Proposed Revisions to a Standard Plans Index

Originator:	Turley, Joshua	Index Number:	649-010
Date:	2/6/2024	Sheet Number(s):	2 and 3
E-mail:	Joshua.Turley@dot.state.fl.us	Index Title:	Steel Strain Pole

STEEL STRAIN POLE

SECTION A-A

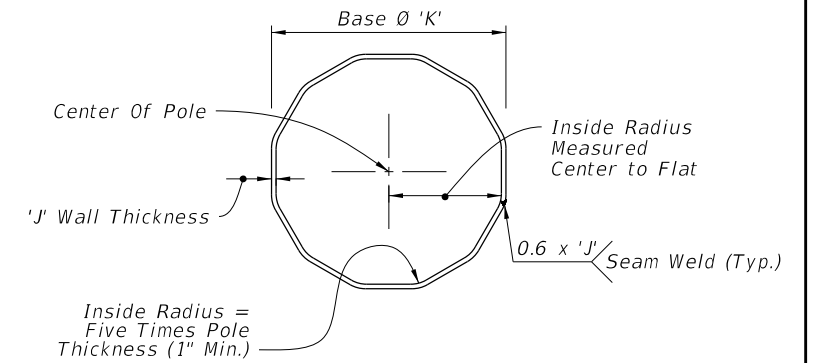
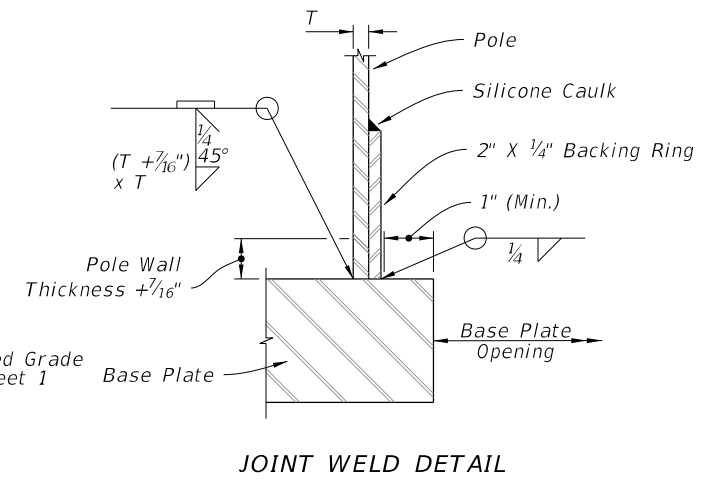
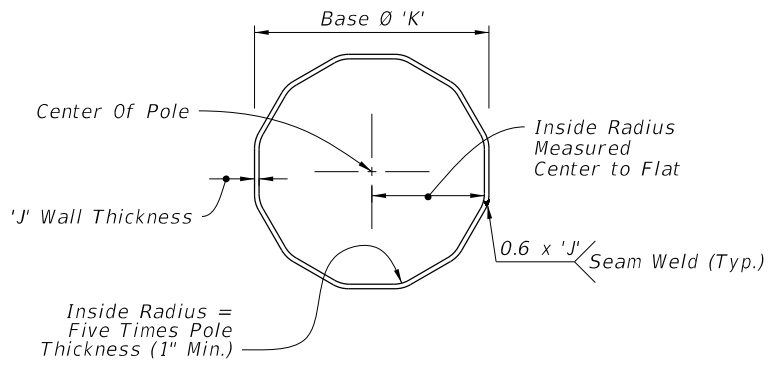
Sheet 2: Section A-A - Revised the label order of the anchor bolt nuts. DETAIL "A" - removed welding hatches, Modified wall thickness from text to symbol.

HANDHOLE FRAME

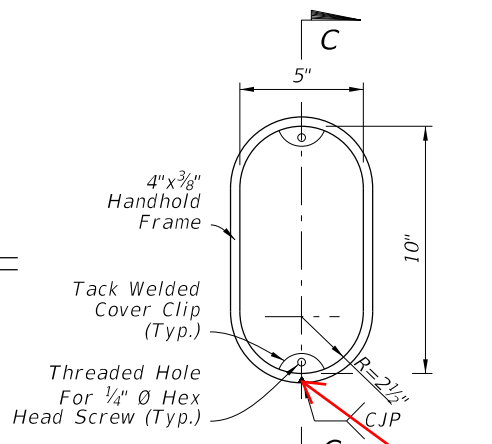
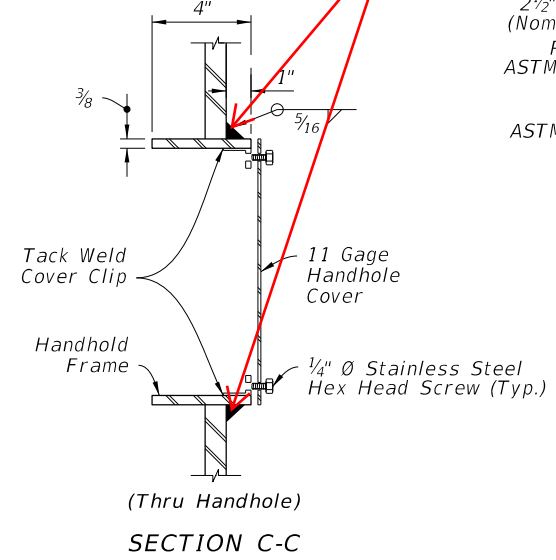
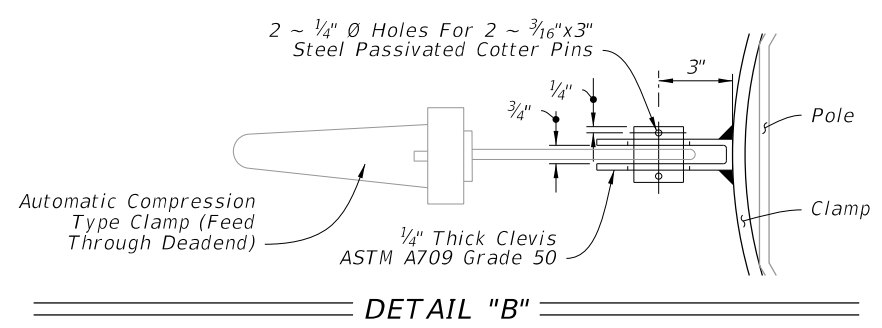
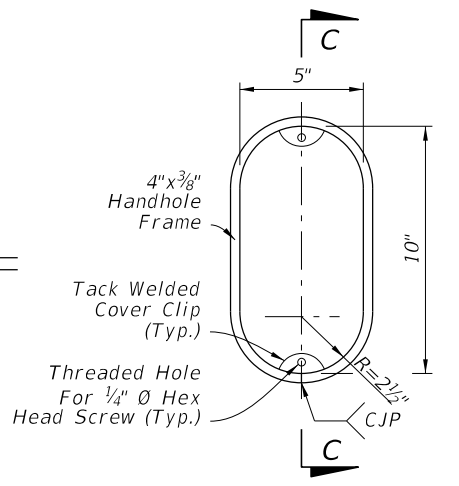
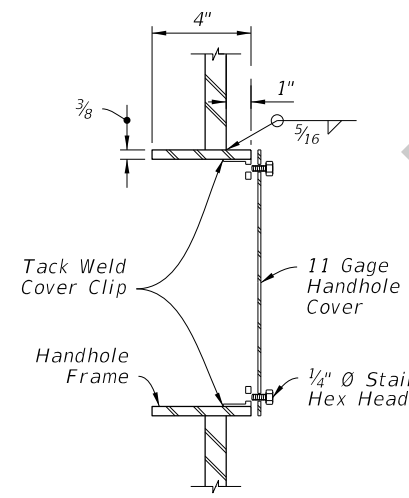
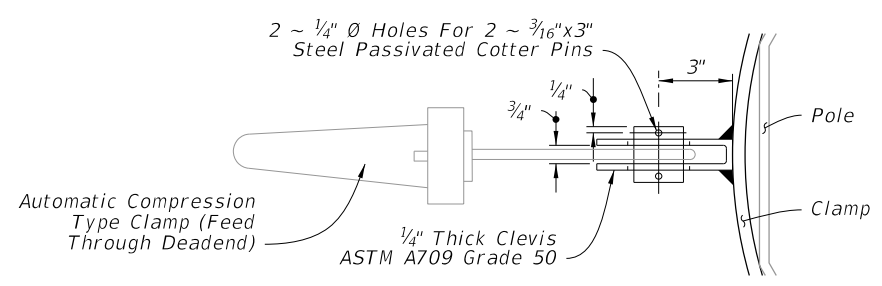
Sheet 3: Removed welding hatches on HANDHOLE details. Added "Handhole" to frame detail label.
